## Lake Lanier Association Goal: A FULL and CLEAN Lake Lanier

## RIOP – Flawed Concept

## JWLD Minimum Release Issues

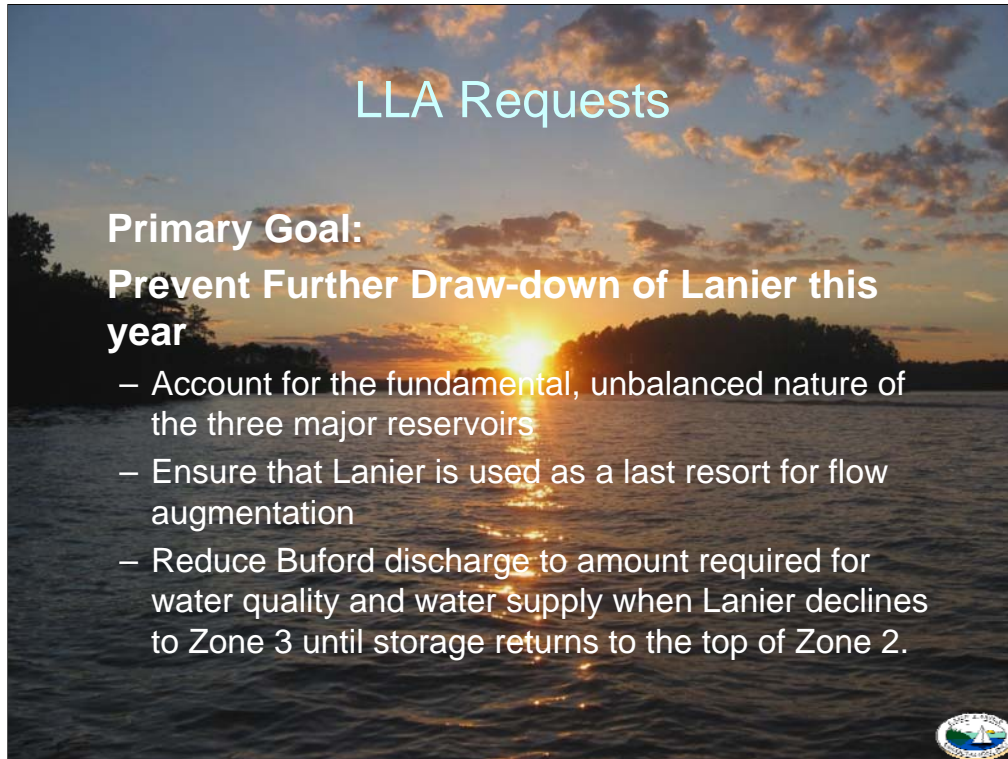
- RIOP provisions for minimum releases use triggers that are too high and storage percentages that are too low
- RIOP does not allow any storage if BI <8,000 cfs EXCEPT in the winter or during DCO.
- During the spawning period, the RIOP does not allow any storage if BI <11,000 cfs in Zone 3, and 16,000 cfs in Zones 1 & 2.
- The result is missed opportunity for storing water when it is needed the most

Before allowing storage of any BI, the RIOP sets a minimum of 16,000 cfs during Spawning season when composite storage is in Zones 1 and 2. But once flows reach ~10,000, the two known spawning sites are covered, and any flow over 11,000 cfs does not provide significant additional spawning sites. Even the FWS has noted that the sturgeon spawned in 2005 and 2006 by using higher portions of rock in higher flows, and lower portions of rock in lower flows.

When composite storage is in Zone 3, the RIOP requires a minimum of 11,000 cfs before any storage is allowed. This would be more consistent with our comments about the minimum flow actually needed.

The RIOP also sets a floor of 34,000 cfs before allowing storage of all flows >25,000 cfs when composite storage is in Zones 1 and 2, but 39,000 cfs when in Zone 3. We question the need for this higher threshold in Zone 3, and would argue for allowing 100% storage in all three Zones at a much lower threshold.

We are also concerned that the RIOP does not allow for storage between 5,000 and 8,000 cfs during the “non-spawning” period when composite storage is in Zones 1, 2, and 3. Flows during the summer months are typically low, and preventing storage during these times when Lanier is already very low unnecessarily limits the ability of Lanier to recover. By sporadically increasing unsustained flows up to 8,000 cfs, the RIOP may harm mussels by enticing them to move to higher ground when flows will not sustain them there for long.

In summary: in Zones 1, 2, and 3 between March and November, we would recommend that the Corps give itself additional leeway by raising the percentage of BI available for storage from 50% to 100% and lowering the threshold to 11,000 cfs - to help avoid the type of extreme low storage situation we are experiencing now.

## Keep Lanier As Full As Possible

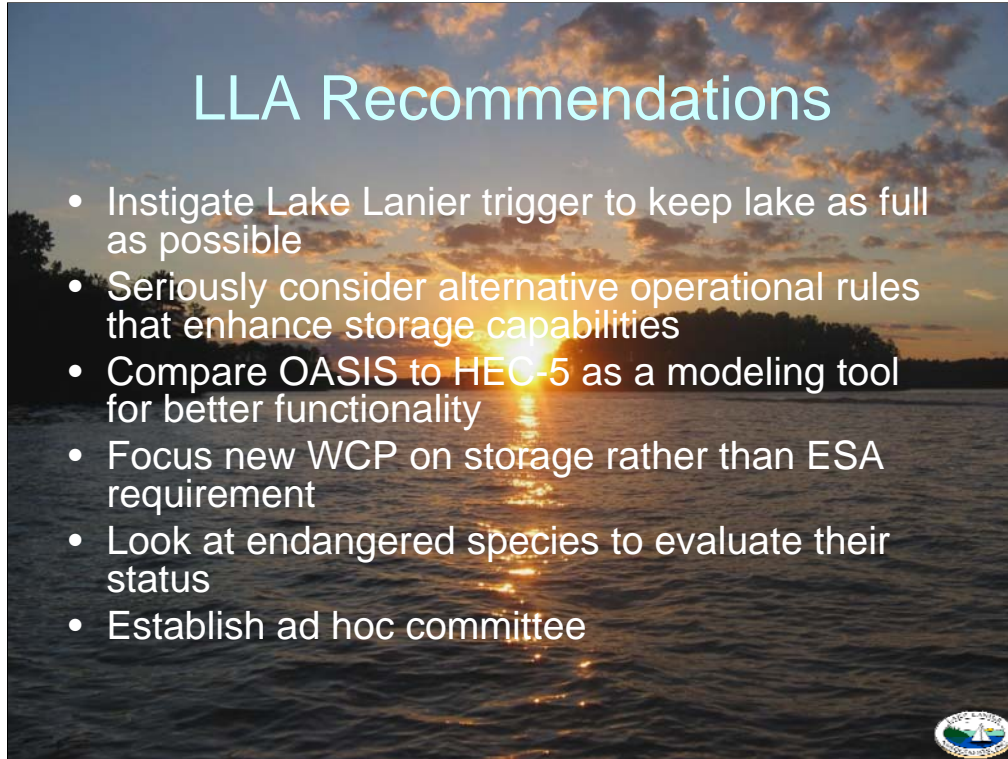
- Maximize storage when basin inflows are comparatively high, even during drought
- Implement Lanier management policies that will reduce discharges when Lanier is in Zones 2 or 3
  - Consider techniques such as reducing peak power generation, that would keep Lanier as high as possible
  - Increase the percentage of basin inflow that can be stored during spawning and "non-spawning" seasons
  - Lower the thresholds at which basin inflow can be stored (i.e., lower the seasonal minimum releases from JWLD)

Our long-term goals include keeping Lanier as full as possible in terms of plentiful BI. We would encourage the Corps to explore ways of reducing flows out of Lanier during such times, and of maximizing the ability of the Lake to refill as well. It is sound logic to preserve Lanier at the highest levels possible in order to provide a cushion in times of drought, which have become much more frequent and severe in recent years.
